Mapua FCC Site Remediation – Review of Post-remediation Monitoring

∴ Prepared for
Ministry for the Environment

∴ November 2011

PATTLE DELAMORE PARTNERS LTD

Figure 1: Comparison of analytical methods – DDX and ADL

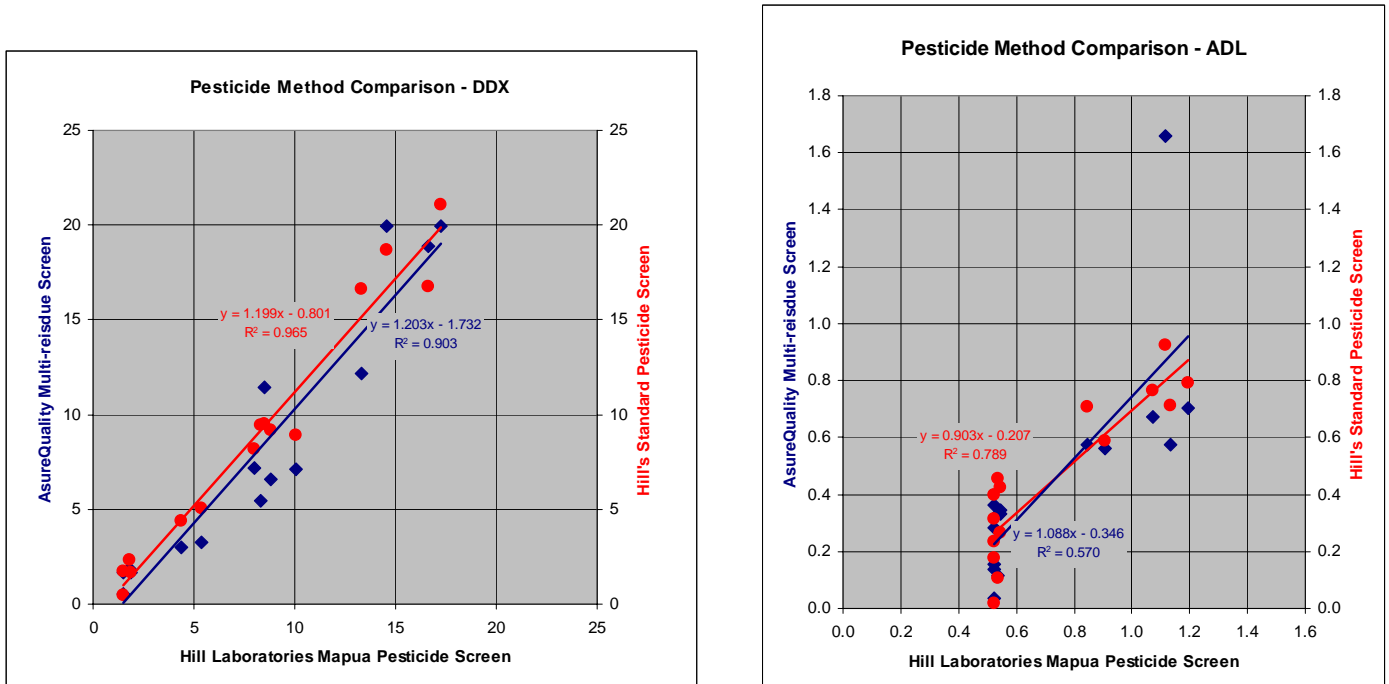
As a first comparison, the Hills Standard and AsureQuality results have both been compared with the Hills Mapua Screen results in Figure 1 below.

Looking firstly at DDX, there is a reasonable one-to-one relationship between the Mapua Screen and the other two, more accurate, analysis methods. Plotting of linear least squares regression lines with the screen method as the independent variable produces similar lines for the two more accurate methods. This gives reasonable confidence that the two more accurate analysis methods are producing close to the “true” concentration, as is the Mapua Screen method.

Considering compliance with the DDX SAC, using one or other of the more accurate methods would have resulted in essentially the same decision as that arrived at using the screen method. The AsureQuality results give a marginally lower estimate for DDX than the two Hill’s methods. This means that the Hill’s methods would have rejected some soil that would have been accepted if analysed by AsureQuality, i.e. both Hills methods are conservative relative to the AsureQuality method.

For ADL there is also a reasonable one to one relationship between the methods, although because there is “left censoring” for the screen method data (i.e. results are below the detection limit) there is a range of results for the more accurate methods for the same or similar apparent value for the screen method. This is an artefact of the high detection limits for the ADL components, but is unimportant as this effect is well below the SAC for ADL.

The relationship between the AsureQuality and the Mapua Screen method ADL results is poorer than between the two Hill’s methods. The regression line for the AsureQuality results is biased by a single high result, which appears to be a statistical outlier. If this result was excluded then a better relationship is achieved. Excluding the outlier and the non-detect values, the AsureQuality results are, on average, lower than the corresponding Hill’s results. If these also applied at the SAC (which is above the range of results) the consequence would be more conservative decisions using the Hill’s methods than the AsureQuality method.

Figure 2: Variation of Snail and Sediment DDX and Dieldrin Concentrations with Time

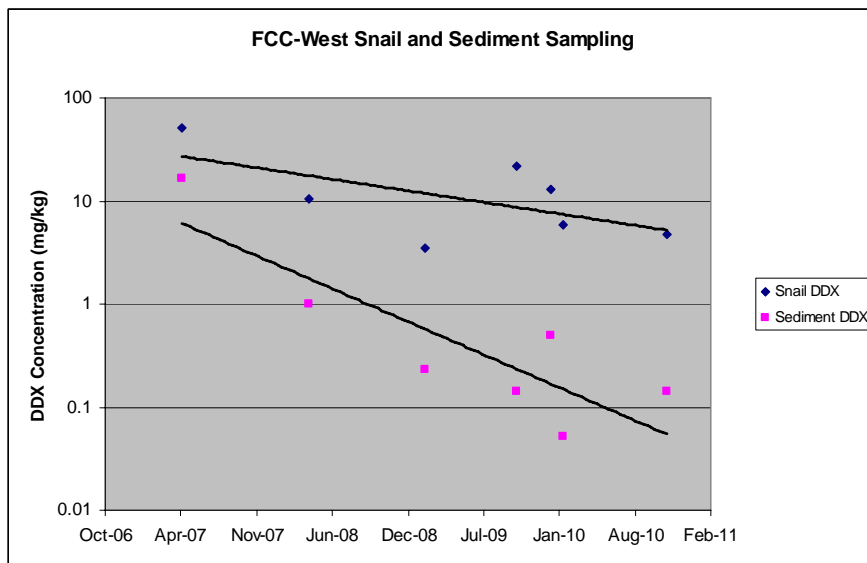
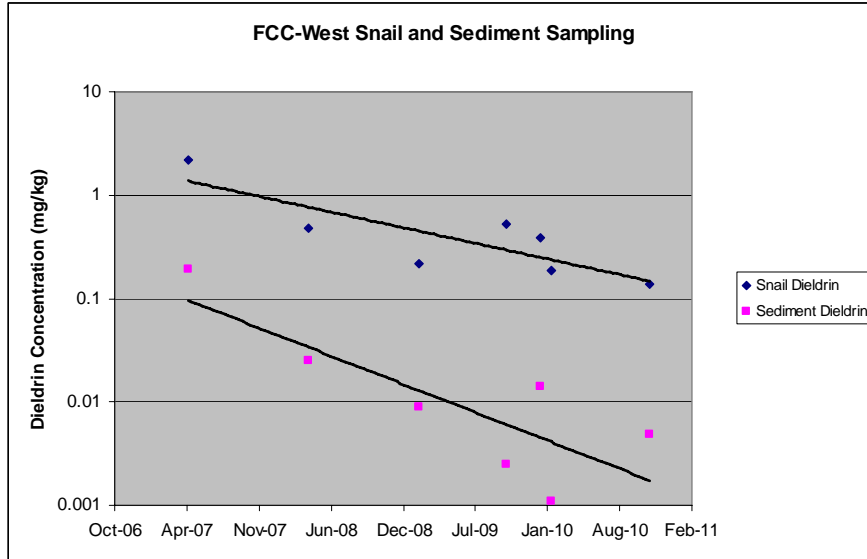
When plotted against time (see Figure 2 next page) a reducing trend for sediment and snails for both DDX and dieldrin is apparent, although there is a relatively large amount of scatter (e.g. the October 2009 results). The lines fitted to the data (exponential, which show as straight lines on semi-logarithmic plots) suggest a reducing trend. The trend shown is probably too steep, with the line expected to flatten out with time if more data were available.

Davidson et al. (2010) showed a similar reducing trend (in the bar plot of Figure 10) for average concentrations in sediment (rather than just the sediment associated with the snail samples) but did not attempt to plot trends in snails.

Figure 3: Snail BAF versus Sediment Concentration

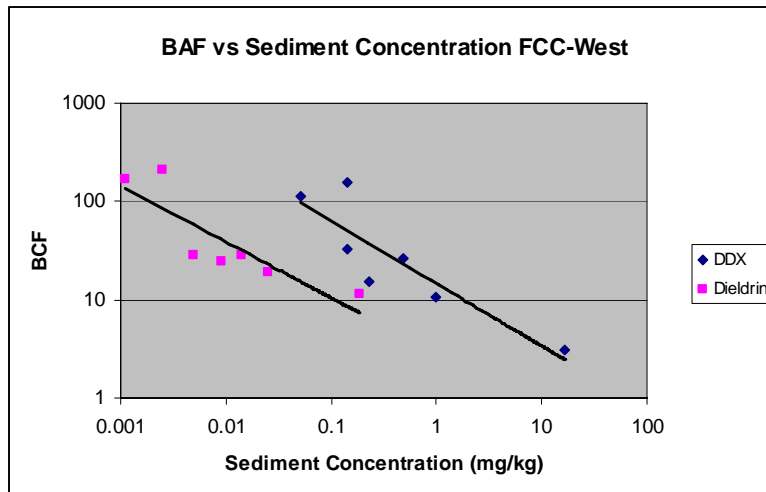
Table 1 also shows calculated bioaccumulation factors (BAF), being the ratio of snail and sediment concentrations. Examination of the data suggests that the BAF may increase as the sediment concentration reduces. To examine this, the BAF values were plotted against sediment concentration (Figure 3).

Again there is considerable scatter (masked by the log-log plot), but the data do suggest an inverse relationship between BAF and sediment concentration. While there are insufficient data to develop a relationship with any certainty, the trend lines suggest that DDX sediment concentrations less than about 1 – 2 mg/kg will result in the mudflat snail DDX concentration complying with the NZFSA advice (i.e. a BAF of about 10 applies at this concentration). Similarly, for dieldrin a sediment concentration of less than about 0.002 mg/kg may result in compliance with the NZSFA advice (BAF of about 100). (Note: the October 2009 results have a significant influence on the trend lines, suggesting possible statistical outliers).
